DATE:	**March 23, 2015**
TO:	**Joseph A. Valentine, City Manager**
CC:	**Jana Ecker, Planning Director**
FROM:	**Matthew Baka, Senior Planner**
SUBJECT:	**Public Hearing for Final Site Plan & Special Land Use Permit at 2200 Holland – Mercedes-Benz of Bloomfield Hills storage facility**

SUBJECT: **2200 Holland Street – Mercedes Benz of Bloomfield Hills Auto — Final Site Plan Review**

FINAL SITE PLAN REVIEW
2200 Holland
New construction of one-story warehouse and storage building (postponed from the meeting of February 11, 2015)

PROPOSED SITE PLAN

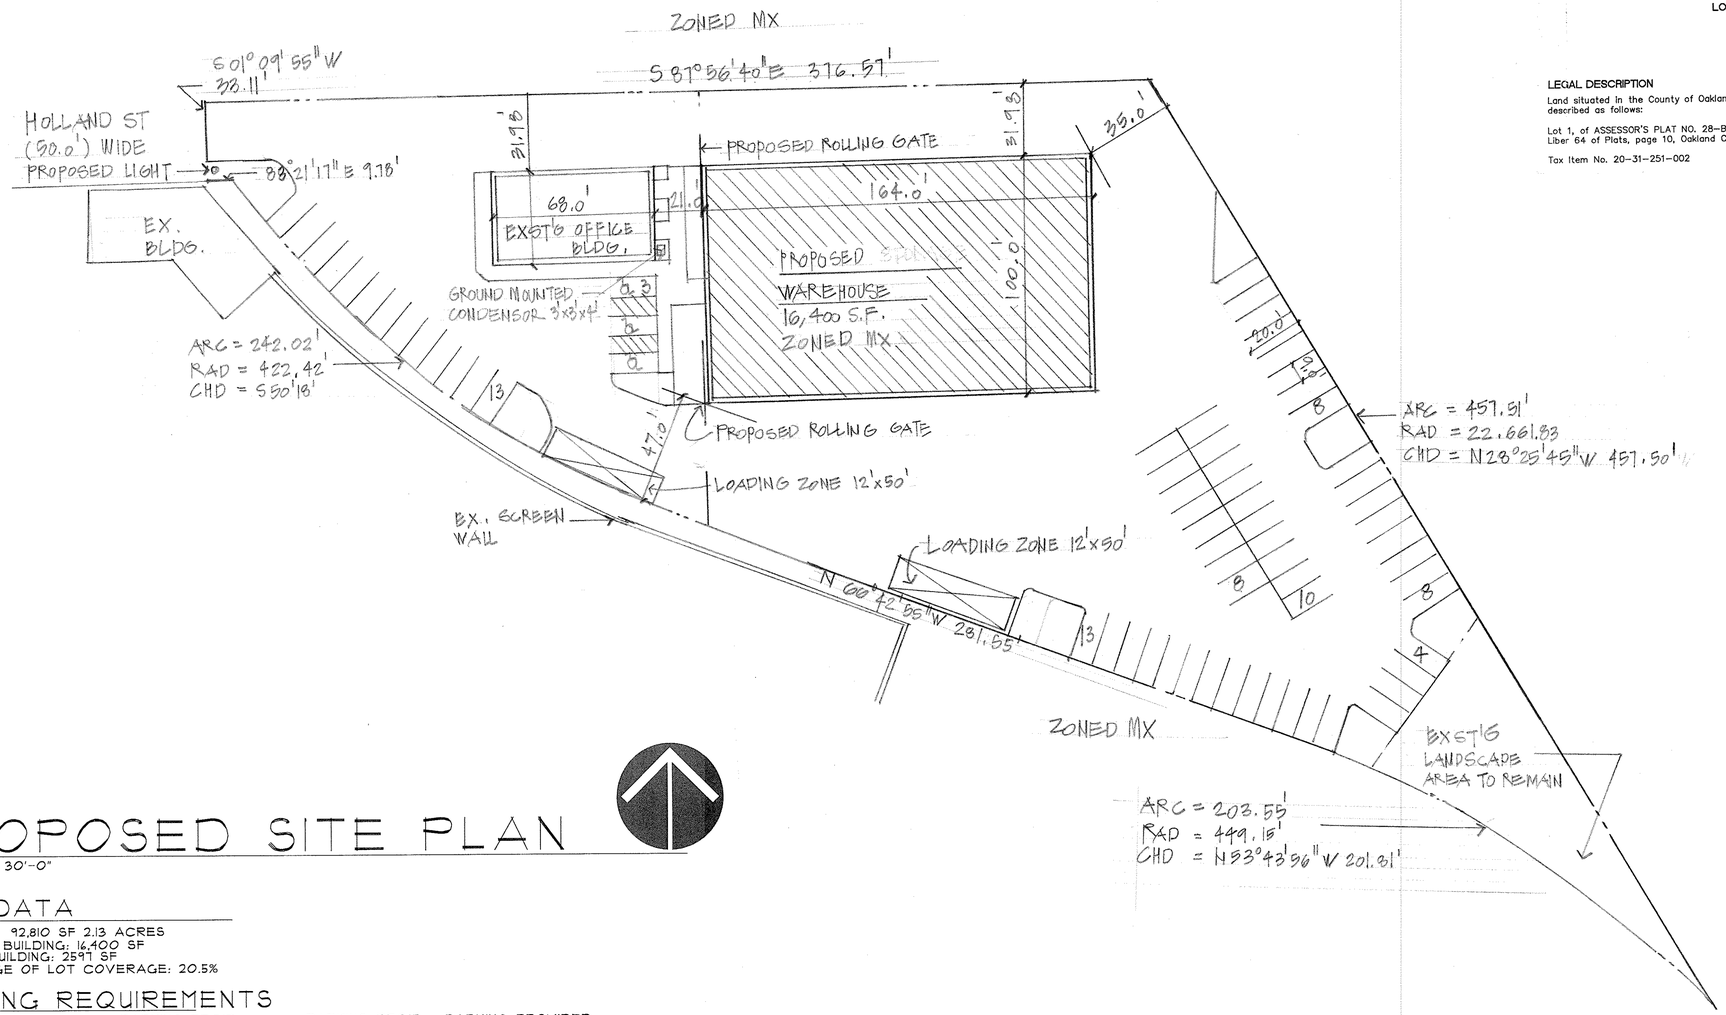
4.1 Parking – In accordance with Article 4, section 4.34 of the Zoning Ordinance, this development is required to have 1 parking space for every 500 square feet of warehouse space and 1 parking space for every 300 square feet of office space. This results in a requirement of 33 parking spaces for the warehouse (16,400 sq. ft. / 500) and 9 parking spaces for the office building (2,597 sq. ft. /300) for a total of 42 spaces required. The applicant has provided 67 parking spaces including three (3) handicap accessible spaces. Accordingly, the applicant's proposal meets the parking requirement. However, in accordance with Article 04, section 4.52 PK-08 A (1), parking is not permitted between the building façade and the frontage line. **The applicant was granted a variance from the Board of Zoning Appeals to allow parking between the building and the frontage line.**

4.2 Loading – The applicant has proposed to have a 12' X 50' loading area on the south side of the building. The loading space meets the requirements of Article 04 section 4.24 (C).

4.3 Vehicular Circulation and Access –Vehicular access to the site is via Holland St. The front portion of the site will contain 16 parking spaces that will service the leasable office space. The applicant proposes to put a security gate on the north and south side of the warehouse that will allow ingress and egress to the Mercedes storage facility. A two way drive lane will allow circulation around the sides and rear of the warehouse allowing access to the roll-up garage doors on the sides and rear of the building as well as access to the parking places.

4.4 Pedestrian Circulation and Access – The applicant has proposed a concrete sidewalk along three sides of the existing office building to allow for pedestrian access from the parking spaces. The walkway on the east side of the office building will be shared with the warehouse. There is currently no pedestrian access along Holland from S. Eton.

1. The current plan does not have any design relative to any underground utilities. Note that the only access the site has to both public water main and combined sewer is at the street connection (the east end of Holland Ave.). Underground drainage accommodating the entire site, as well as a new sanitary service and water service will be required as a part of the building permit for this proposal.

PROPOSED LANDSCAPE PLAN

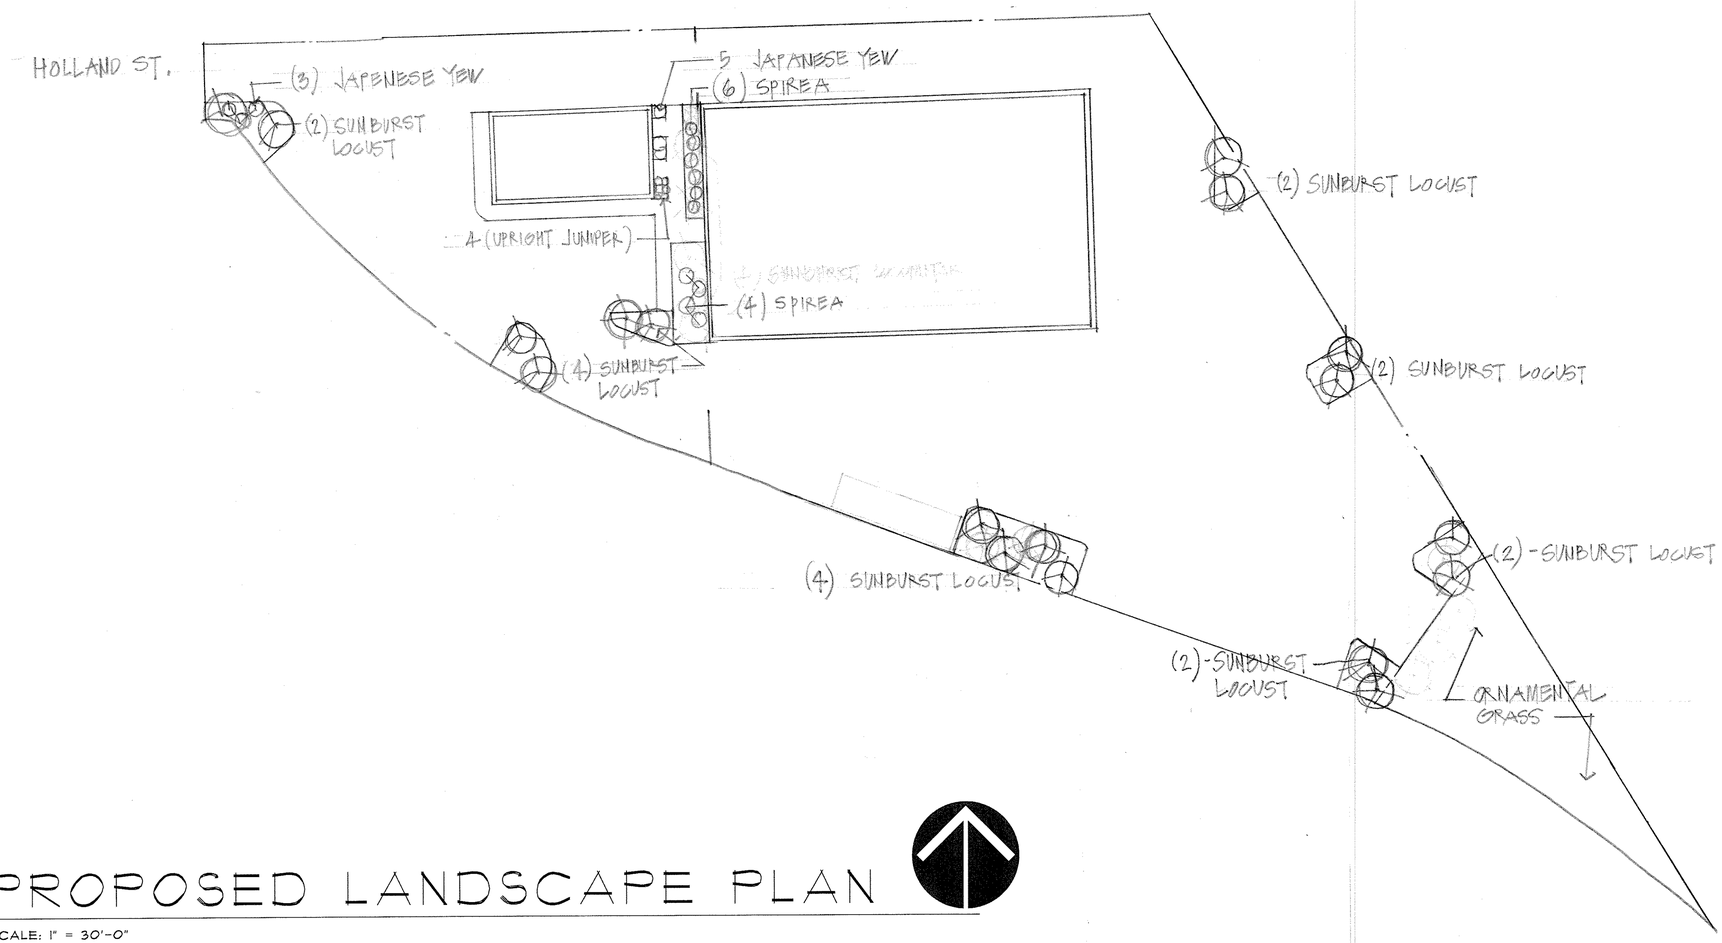
3.4 Landscaping –The applicant has proposed a total of 18 Sunburst Locust Trees, 10 Snow White Spirea, 8 Japanese Yews and a large area of ornamental grass. The landscaping is proposed to be located throughout the site and parking lot in a manner that breaks up the parking area. Three (3) Yews and two (2) Sunburst Locust trees are proposed to be located on the south side of the entry to the site. Two (2) Sunburst Locust, five (5) Japanese Yews and ten (10) Spirea are proposed to be located at the front elevation of the new building. The applicant is proposing a large area of ornamental grass in the southeast corner of the site and four (4) Sunburst Locust trees that will flank the parking spaces immediately adjacent. The remaining ten (10) Sunburst Locust trees are proposed to be arranged throughout the parking lot interior.

Article 4, section 4.20 LA-01 (F) of the Zoning Ordinance requires that parking lots shall have landscaping areas that total no less than 5% of the total parking lot interior. Each interior planting area shall be at least 150 square feet and not less than 8 feet in any single dimension, there shall be at least on canopy tree for each 150 square feet and the interior planting areas must be located in a manner that breaks up the expanse of paving throughout the parking lot interior.

The plans submitted by the applicant indicate the proposed parking area will be 53,370 sq. ft. in size. Accordingly, the applicant is required to provide 2,668 sq. ft. of landscaping and 18 canopy trees. The applicant indicates that 3,450 sq. ft. of

landscaping and the plans show eighteen (18) canopy trees will be provided in the parking lot interior. **Accordingly, the proposal meets the ordinance requirements in regards to parking lot landscaping.**

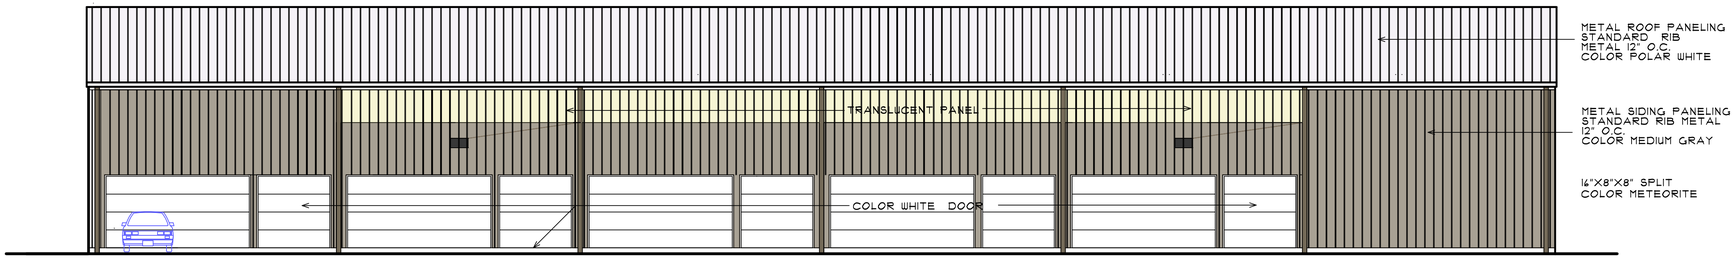
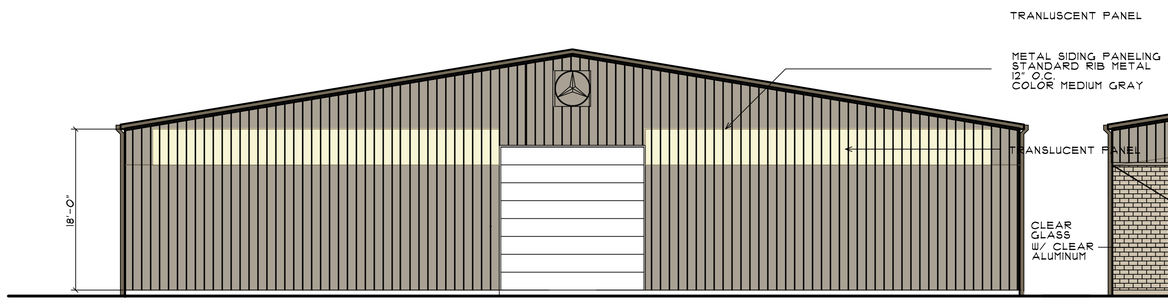
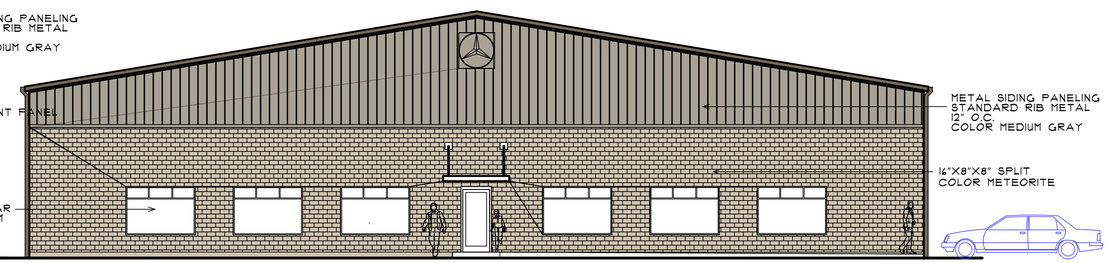
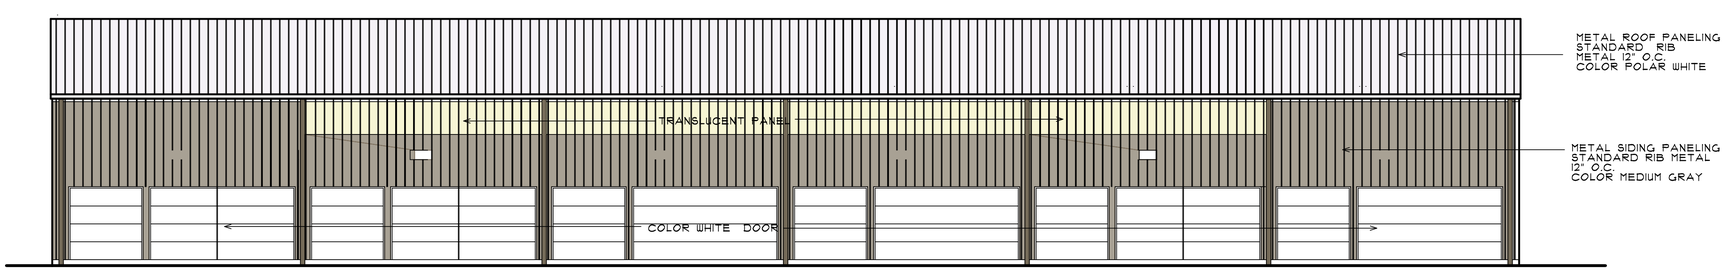
Front (East) Elevation

The front elevation of the new warehouse structure is proposed to be primarily constructed of 16" x 8" split face block in a beige color. The split face block will extend up the façade approximately 16'. There are six (6) clear glass windows proposed for the front elevation which will be 8' x 5' each with beige frames. One single door is proposed in the center of the front elevation with a small canopy overhead. The upper portion of the front façade will be constructed of beige translucent panels. A Mercedes-Benz logo is proposed to be centered on the front façade approximately 22' above grade.

North/South Elevations

The north and south elevation of the warehouse are proposed to be constructed of beige metal panels from grade to 16' with beige overhead doors lining each side. The south elevation is proposed to have twelve (12) doors and the north elevation is proposed to have ten (10) doors. The upper five (5) of the side elevations will be constructed of beige translucent panels up to the eaves.

Rear (West) Elevation

The rear elevation is proposed to be constructed completely of beige metal panels with one large 16' x 16' overhead door in the center. A Mercedes-Benz logo is proposed to be centered on the rear façade approximately 22' above grade.

In addition, this parcel is subject to the window requirements of Article 04 section 4.83 WN-01, which requires 70% glazing on any façade that faces a street, plaza, park or parking area. The plans as submitted do not meet this requirement. **The applicant was granted a variance from the Board of Zoning Appeals to provide less than 70% glazing on the first floor.**

Plan View
Scale 1" = 30'

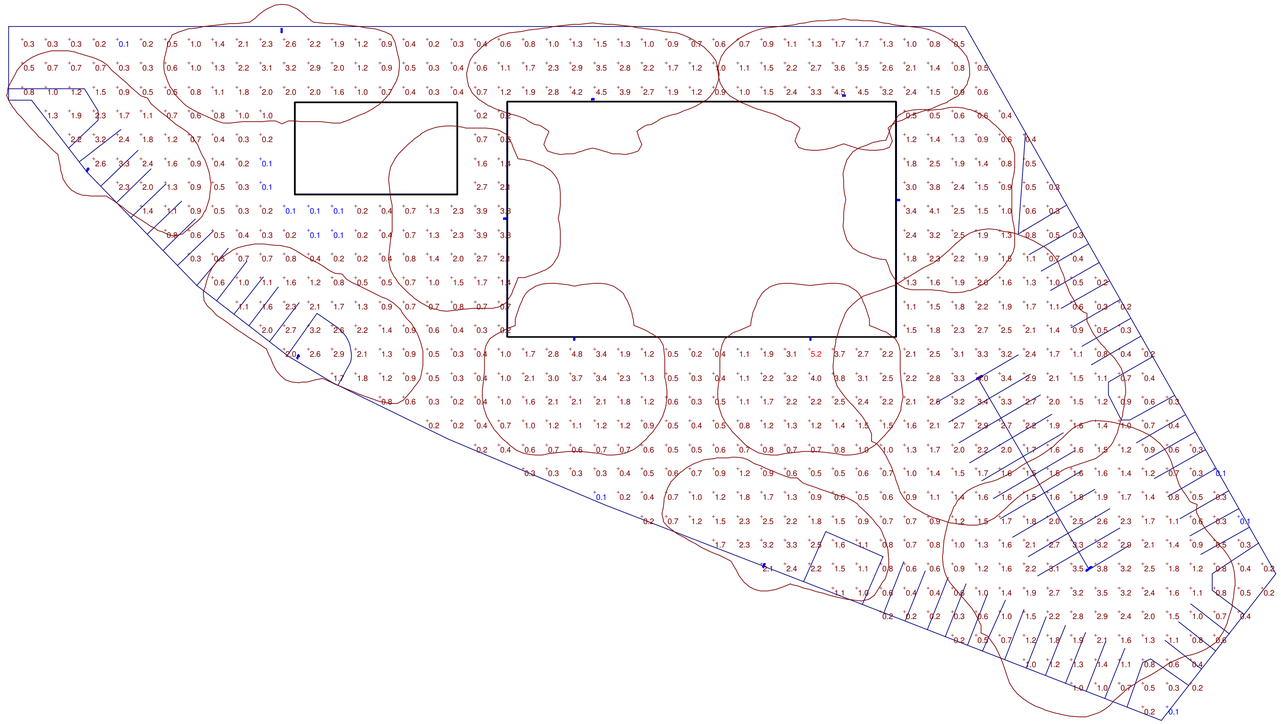
1. The applicant revises the photometric plan to meet the requirements of the Zoning Ordinance or obtain a variance from the Board of Zoning Appeals.

In addition, the applicant is now proposing to install exterior parking lot lighting on the site. Accordingly, the proposed lighting must meet the requirements of Article 04 section 4.21 LT-01, Lighting Standards. The applicant is proposing to install six wall mounted lights on the perimeter of the new warehouse at a mounting height of 16'. The plan also calls for six (6) pole mounted light fixtures, four (4) of which are single head fixtures and two are double head fixtures. The photometric plan that has been submitted indicates that the light poles are proposed to be 27.5' in height. The Zoning Ordinance restricts the height of pole mounted lights to 16' in height. **Accordingly, the applicant will be required to revise the photometric plan to meet the requirements of the Zoning Ordinance or obtain a variance from the Board of Zoning Appeals.**
